**SUBJECT: PIER 4 PHASE 2 RECONFIGURATION**  
PROJECT NO. 091251  
CONTRACT NO. 070136

**ADDENDUM NUMBER FOUR**

# ENLARGED ELECTRICAL PLAN SUBSTATION #8410

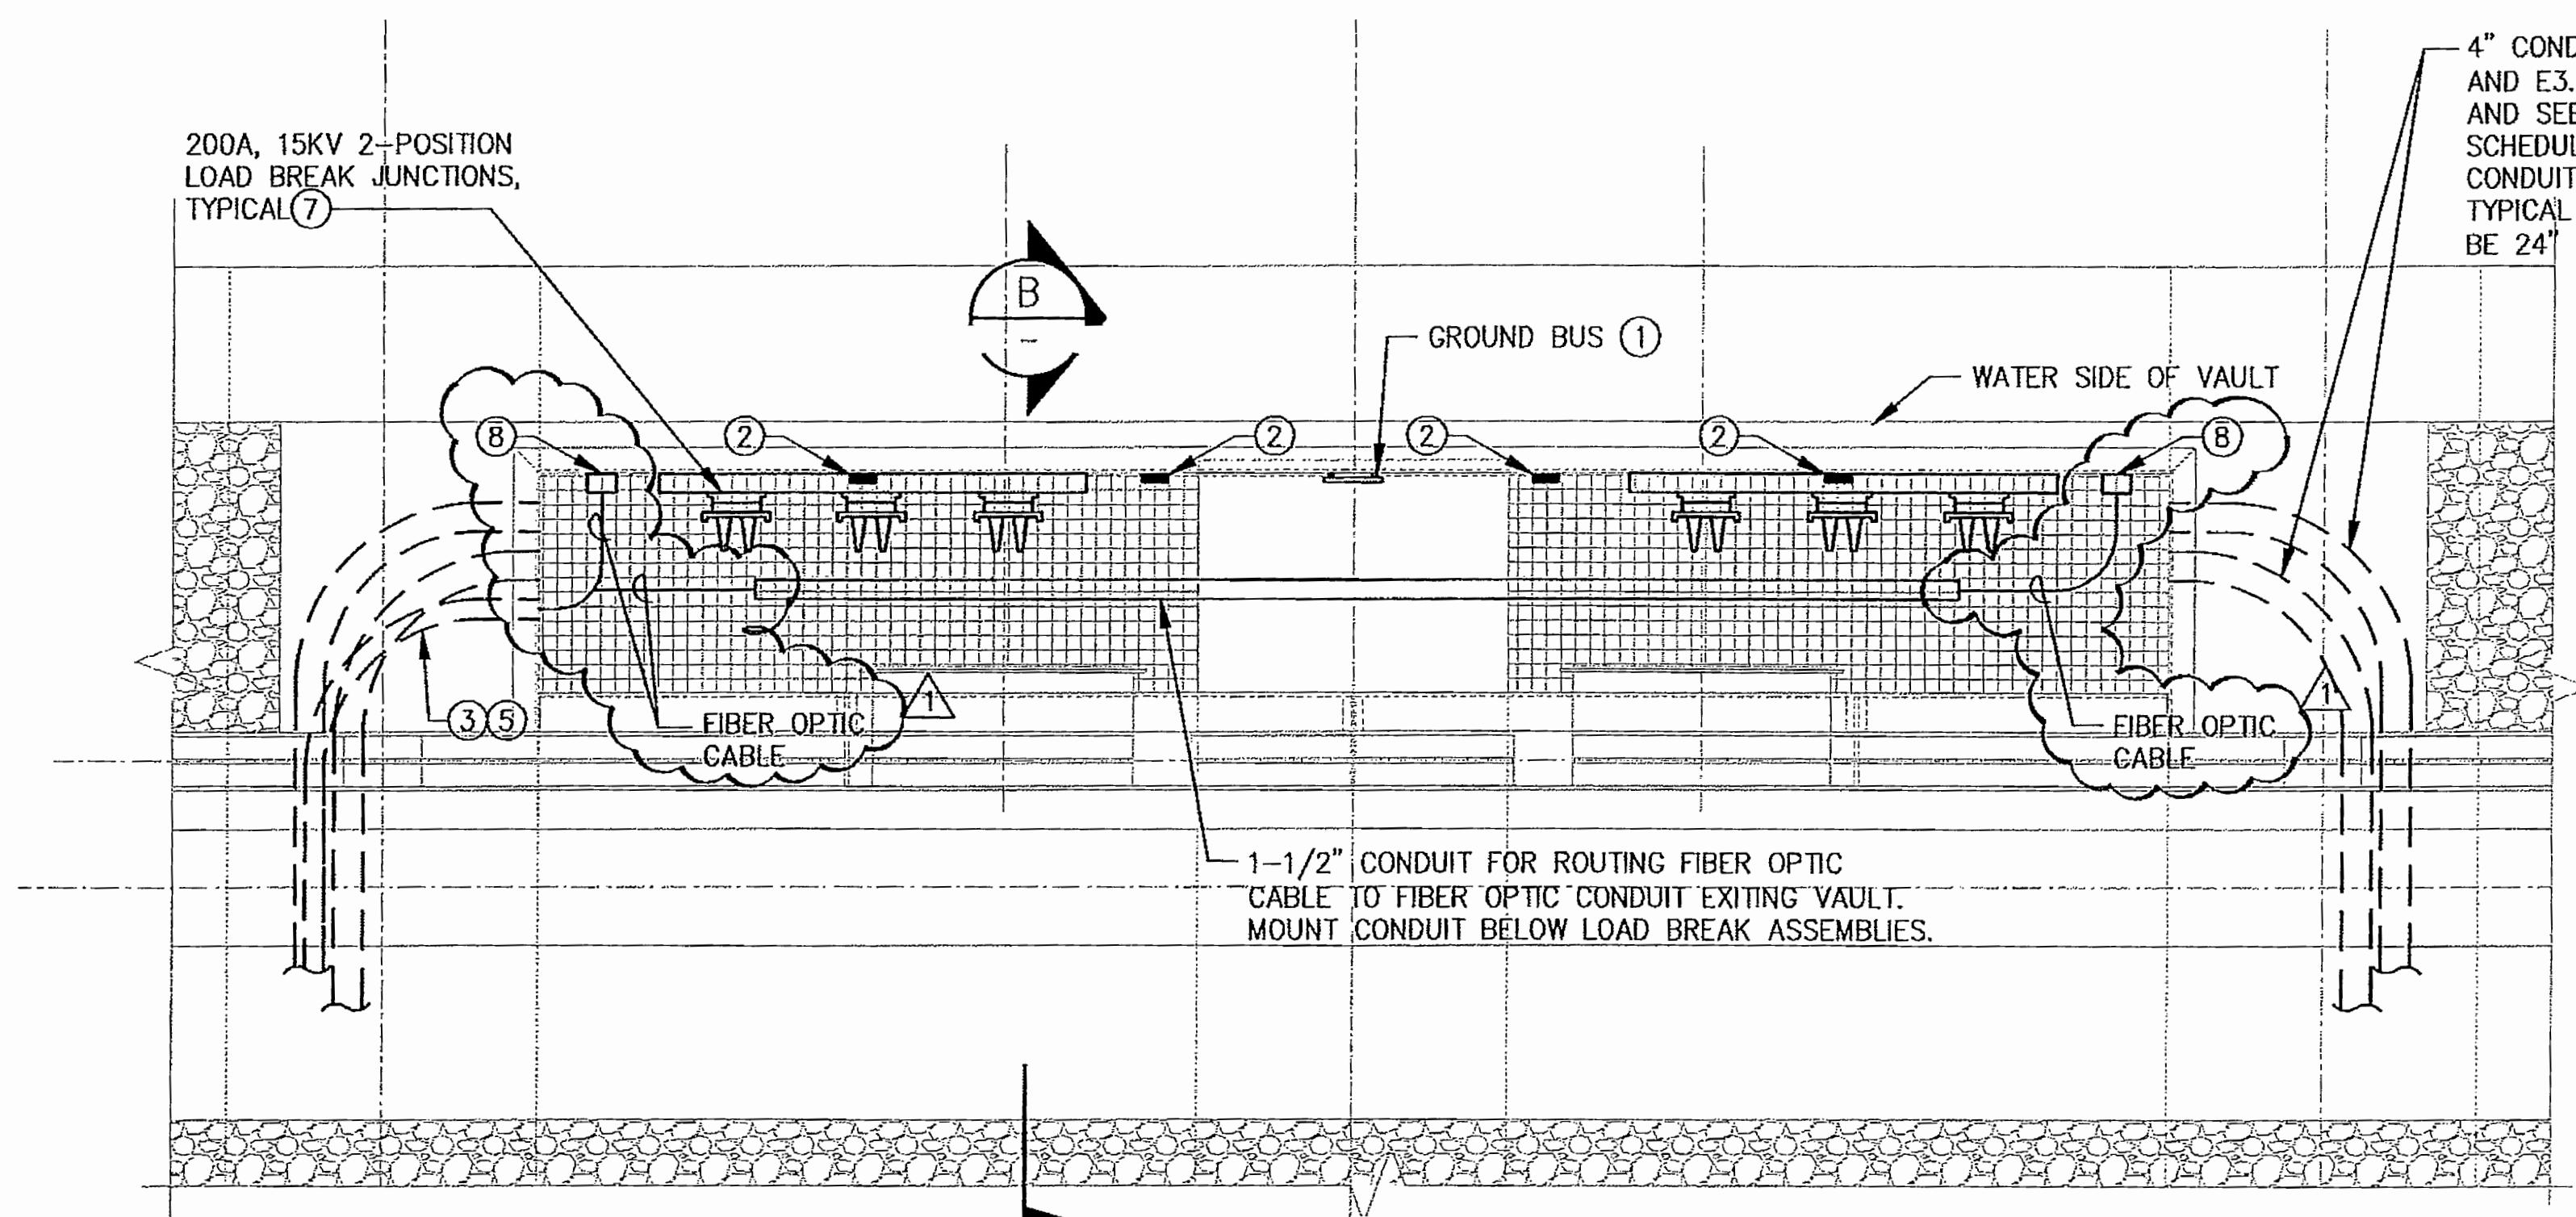
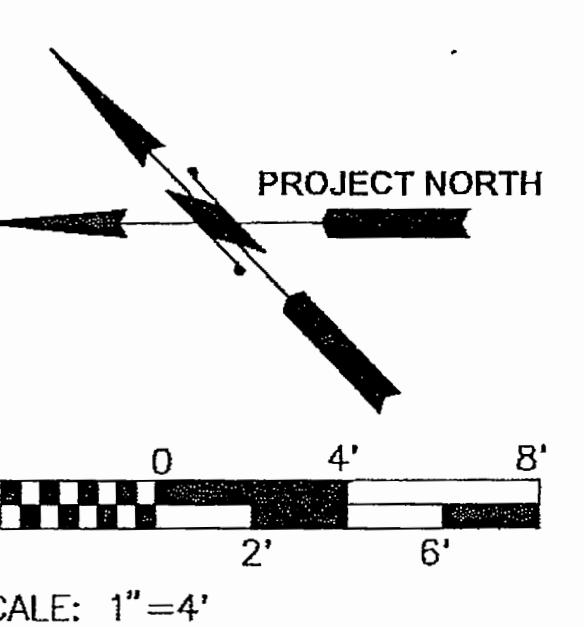
1. **REVISE** Key Note 2 as follows:
  2. PROVIDE MINIMUM 9" ABOVE FINISHED GRADE, RE-BAR REINFORCED, CONCRETE PAD BELOW ~~SWITCHGEAR BUILDING~~ PDSE SWITCHGEAR ENCLOSURE. SEE SPECIFICATION 33 77 00, PARAGRAPH 2.04, FOR PDSE REQUIREMENTS. PROVIDE BLOCK-OUTS IN CONCRETE PAD BELOW SWITCHGEAR FOR CONDUIT ACCESS. CONTRACTOR AS PART OF THE SHOP DRAWINGS SHALL PROVIDE CONCRETE PAD SUBMITTAL THAT HAS BEEN DESIGNED AND STAMPED BY ~~THE~~ A STRUCTURAL ENGINEER. SEE SPECIFICATIONS ... (See Attachment B to this Addendum No. 04)
2. **ADD** underground conduit and cable between 15KV Main Switch and the switchgear. (See Attachment B to this Addendum No. 04)

- ① VAULT TO BE PER TACOMA POWER STANDARDS.
- ② PROVIDE MINIMUM 9" ABOVE FINISHED GRADE, RE-BAR REINFORCED, CONCRETE PAD BELOW PDSE SWITCHGEAR ENCLOSURE. SEE SPECIFICATION 33 77 00, PARAGRAPH 2.04, FOR PDSE REQUIREMENTS. PROVIDE BLOCK-OUTS IN CONCRETE PAD BELOW SWITCHGEAR FOR CONDUIT ACCESS. CONTRACTOR AS PART OF THE SHOP DRAWINGS SHALL PROVIDE CONCRETE PAD SUBMITTAL THAT HAS BEEN DESIGNED AND STAMPED BY A STRUCTURAL ENGINEER. SEE SPECIFICATIONS 03 10 00, 03 20 00, AND 03 30 00 FOR CONCRETE SLAB AND REINFORCING CONSTRUCTION REQUIREMENTS.

1 CRANE POWER VAULT PLAN

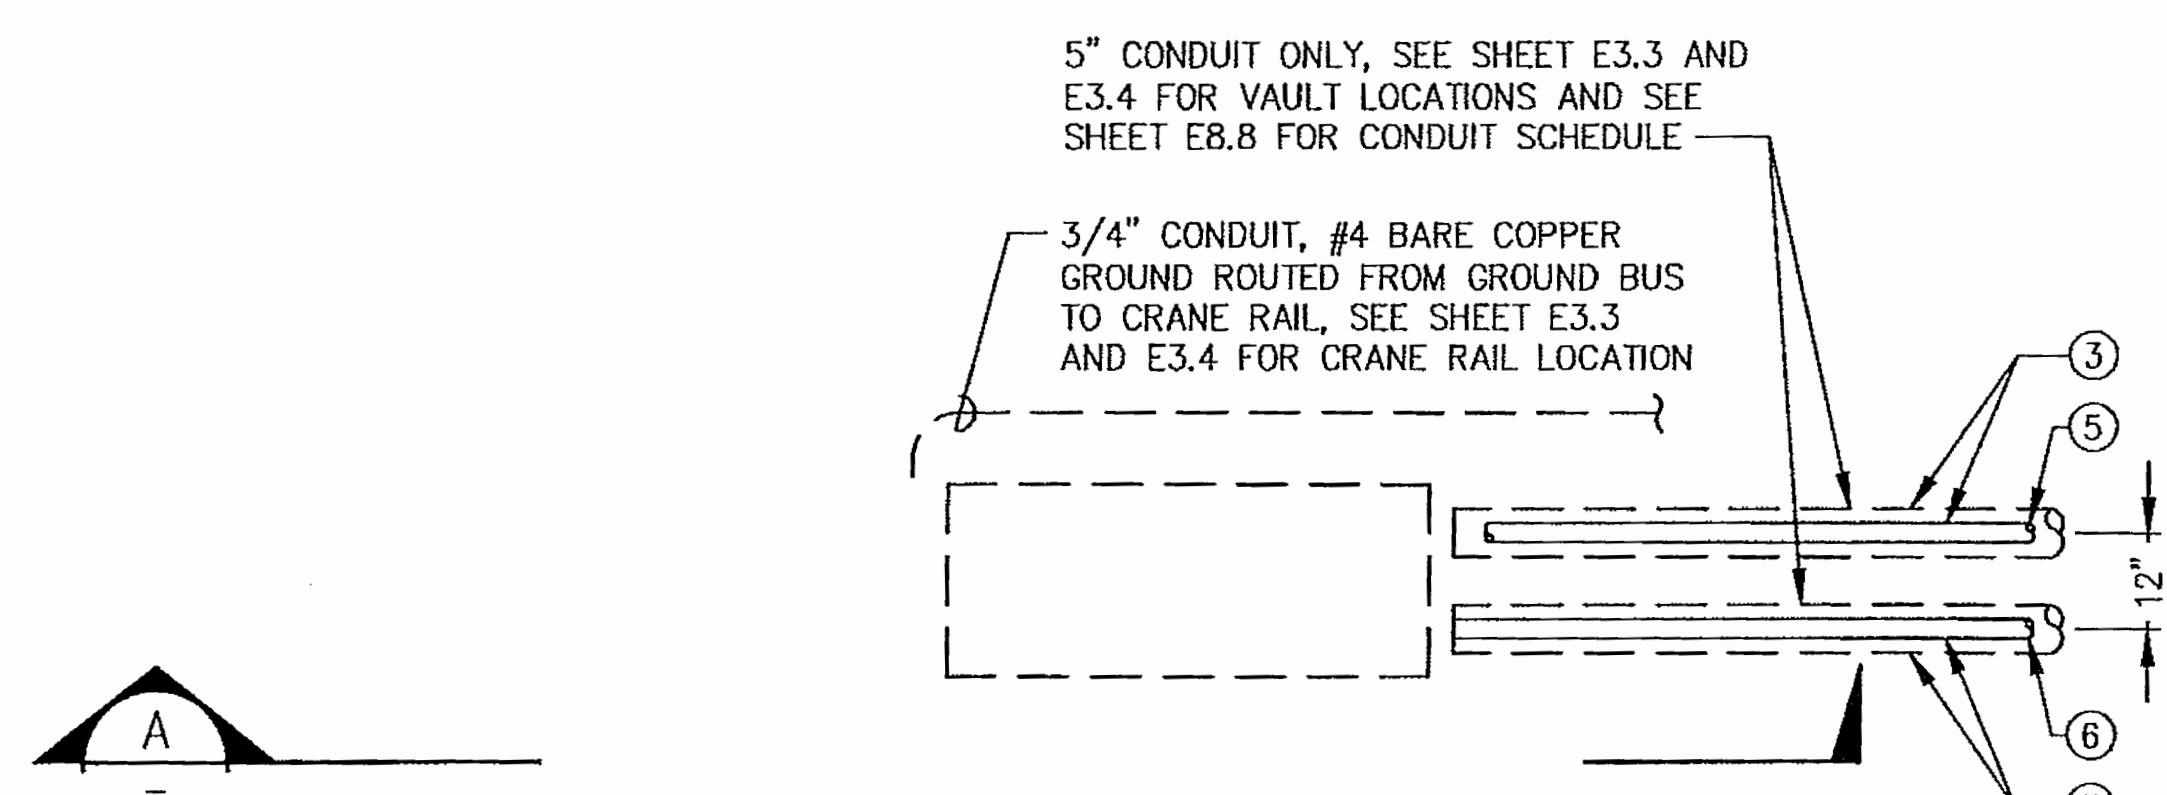
1. **ADD** fiber optic cables and splice enclosures in crane vault for terminating fiber optic cables. See key note #8 and Detail 1 Crane Power Vault Plan. (See Attachment C to this Addendum No. 04)

- ⑦ JUNCTION TO BE ADJUSTABLE TYPE SET AT 45 DEGREES UP, MOUNT AT +46" ABOVE GRATING.
- ⑧ COMMSCOPE TYPE FOSC 450 SPLICE CLOSURE, # FOSC 450-A4-2-12-1-A-1-V, OR ENGINEER APPROVED EQUAL, WALL MOUNT VERTICALLY AT +36" ABOVE FLOOR GRATING TO TOP OF ENCLOSURE.
